Technical Service Information

CHRYSLER A518 (46RH) AND 46RE BROKEN FRONT PLANETARY

Figure 1

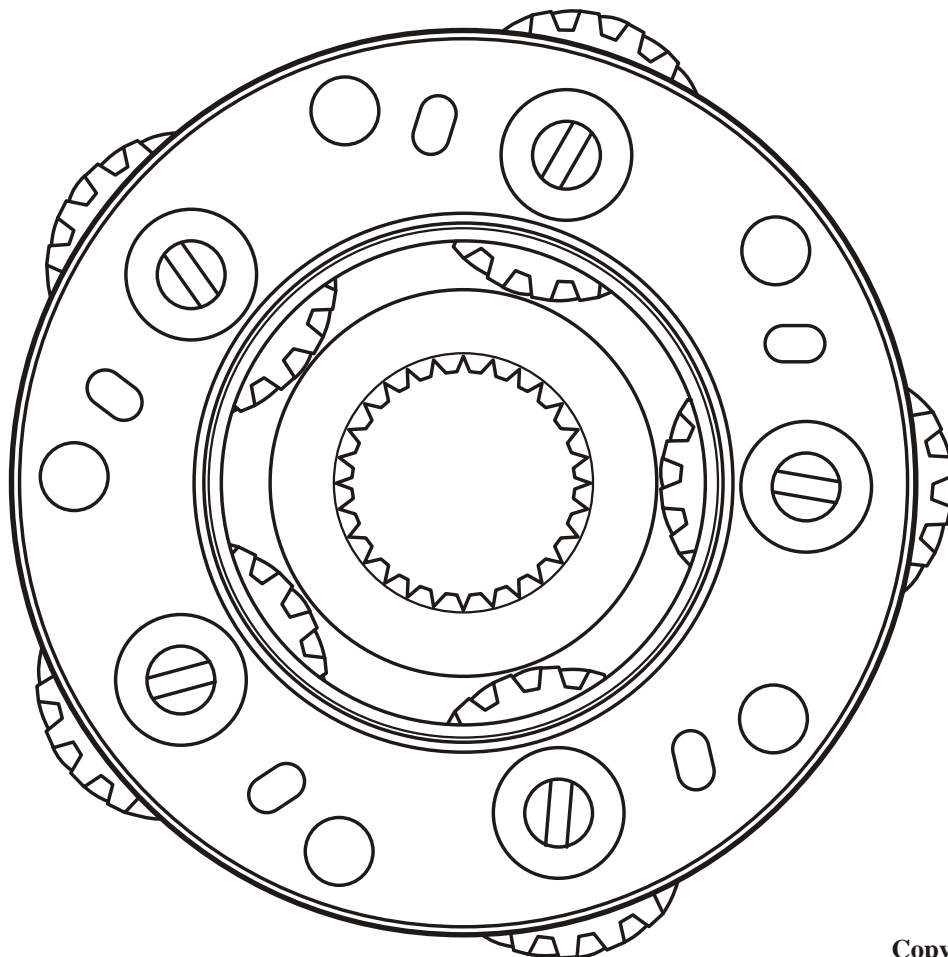
COMPLAINT: Before and/or after rebuild the vehicle returns with the front planetary carrier broken, and will occur with a lot more frequency if it is equipped with the Diesel engine.

CAUSE: Not enough torque carrying capacity with previous design aluminum, 4 pinion carrier.

CORRECTION: There is now available under OEM part number 4617998, a new design 5 pinion, steel front planetary carrier, as shown in Figure 1. The 5 pinion, steel front carrier also requires a 5 tang thrust washer for the back side of the carrier and is available under OEM part number 4539129, as shown in Figure 2. These parts should be installed in all Diesel engine equipped vehicles, and any vehicle carrying heavy loads.

5 PINION STEEL FRONT CARRIER OEM PART NUMBER 4617998
